CITY OF MILWAUKIE

DESIGN AND LANDMARKS COMMITTEE

6.1 Summary: Downtown design review process (continued)

Date: February 24, 2020

Figure: Frontage Occupancy Requirements and Build-To Line

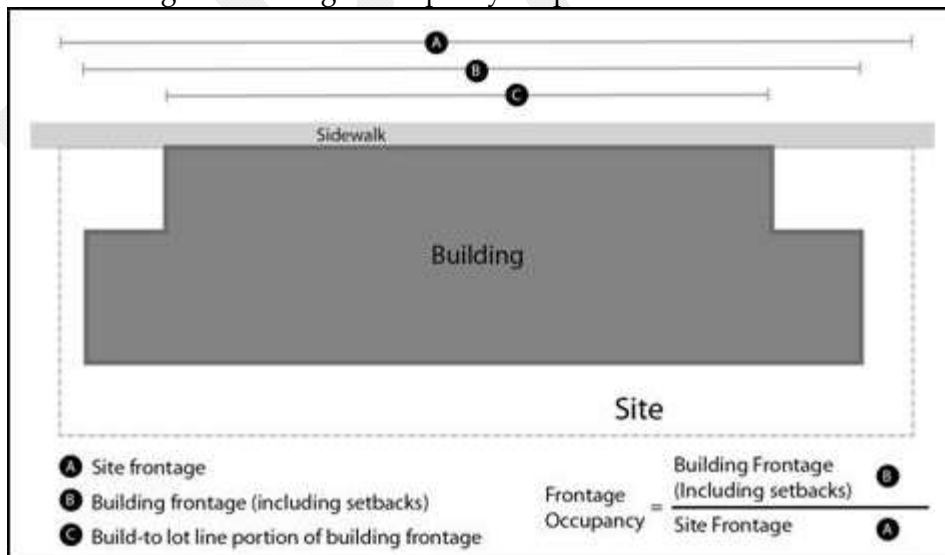
- *Revisions to Minimum frontage occupancy diagram (Figure 19.304-6)*
 - *Designate McLoughlin Blvd with 90% minimum requirement.*
 - *Main St = Set at 75% north of Scott St, at 90% in front of City Hall.*

- *21st Ave = Extend 75% requirement to include the City Hall block.*
 - *Jackson St = Set at 75% west of Main St.*
 - *Jefferson St = Set at 75% on both sides of Main St.*

- *Scott St = Leave at 50% west of Main St.*
 - *[Note: The wastewater treatment plant is separated from the McLoughlin Blvd right-of-way by the Trolley Trail. How to make the requirements apply to that property?]*

Figure: First-Floor Build-To Lines

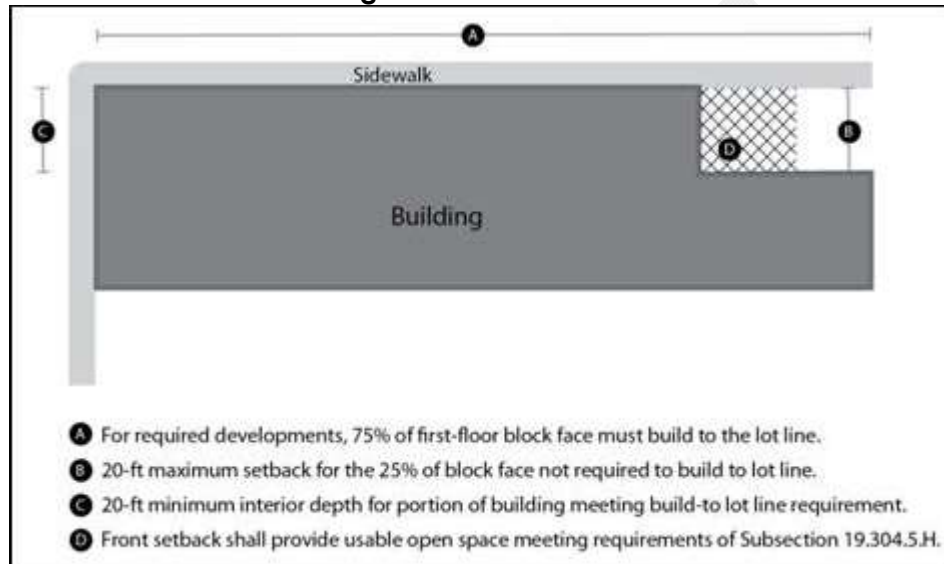
- *Revisions to First-floor build-to lines diagram (Figure 19.304-5)*
 - *Include all block faces downtown, including on McLoughlin Blvd but not the block of Lake Rd/Main St between 21st Ave and Main St (under trestle) or Eagle St adjacent to the sewage treatment plant.*

- *[Note: The wastewater treatment plant is separated from the McLoughlin Blvd right-of-way by the Trolley Trail. How to make the requirements apply to that property?]*

Figure: Flexible Ground-Floor Space Standards

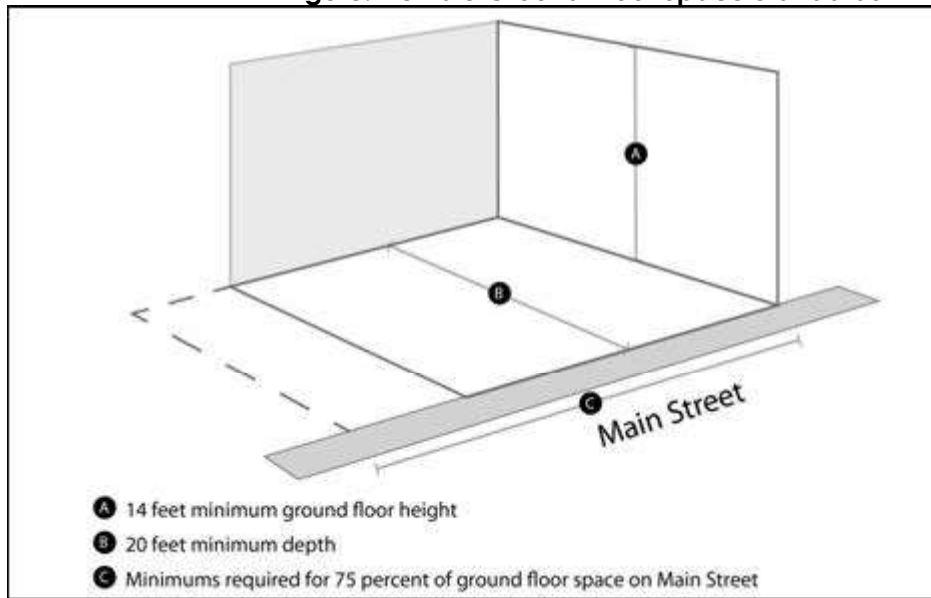
- *Keep graphic illustrating first-floor build-to lines (Figure 19.304.5.D.2.b(1&3))*
- *Keep graphic on flexible ground-floor space standards (Figure 19.304.5.C.2)*
